Bicycle NSW feedback - Charlestown to Whitebridge shared pathway/cycleway

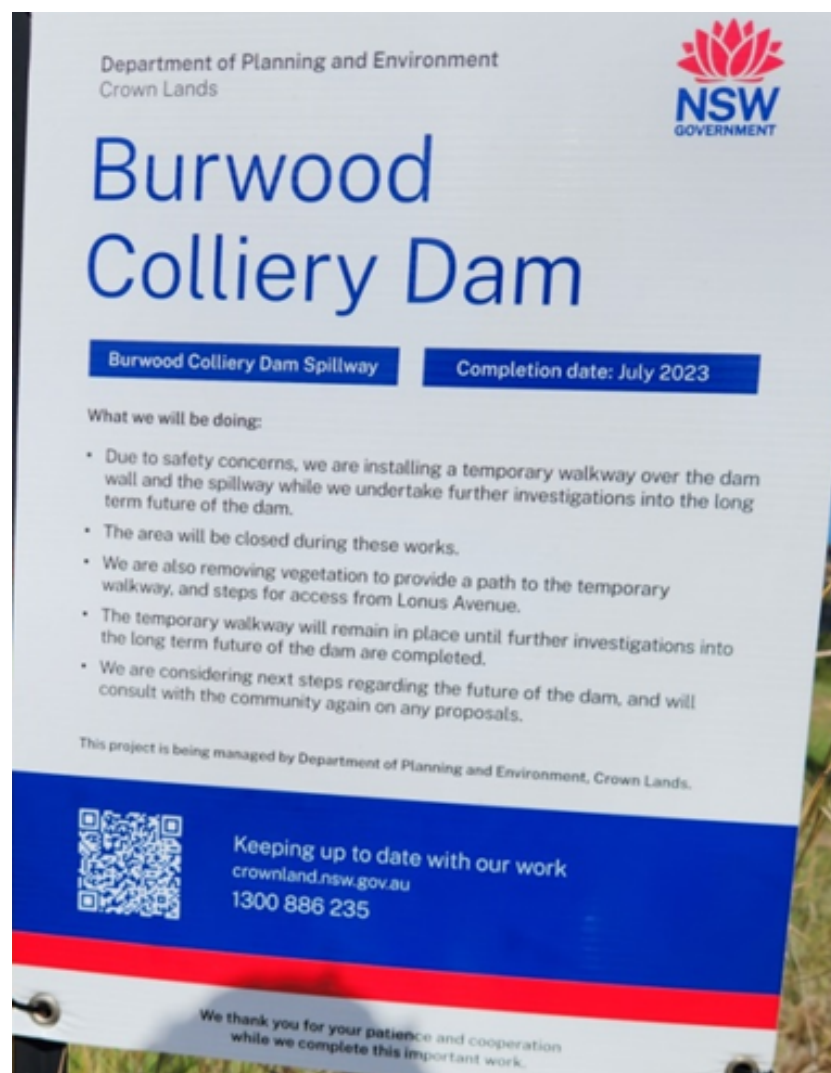
A separated path would be ideal for Lonus Avenue with Quietway treatments used to enable safe on-road riding north of Kurraka Street. However, it is an imperfect world and a shared path would also be an acceptable solution for Lonus Avenue. A shared path has the benefit of creating walking space on the east side where there is currently no footpath. A shared path will be easier for the community to accept in an area very much wedded to cars and resistant to major changes to the road-related environment or loss of parking.

Note that we are not convinced that the proposals will deliver a safe connection to the Whitebridge shops, despite this being stated as a positive outcome for all options. The concept plans do not show the path south of Kopa Street, or any indication of how people on bike will navigate the roundabout at the junction with Dudley Road.
